**RE: Drainage Improvements, Diamondhead City Hall
Change Order No.1**

CHANGE ORDER

PROJECT: Drainage Improvements
to Diamondhead City Hall
Diamondhead, MS 39525

CHANGE ORDER NUMBER: 1

PROPOSED CONCRETE FLUME AT CATCH BASIN NO. 1

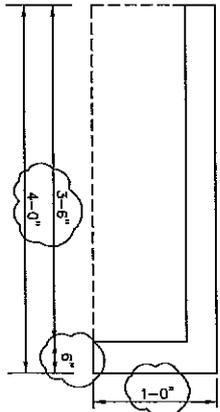
This is a change order for erosion control measures found in the field. Increased runoff crossing the asphalt roadway into new catch basin no. 1 is causing erosion around catch basin. The runoff is increased due to erosion behind the existing sheet pile across the roadway from catch basin no.1. A concrete flume needs to be installed to prevent future erosion around new catch basin no.1. This change order reflects the cost increase for this found condition.

6" WALLS AND TOP WITH #4 @ 12" O.C. EACH WAY OR APPROVED PRECAST
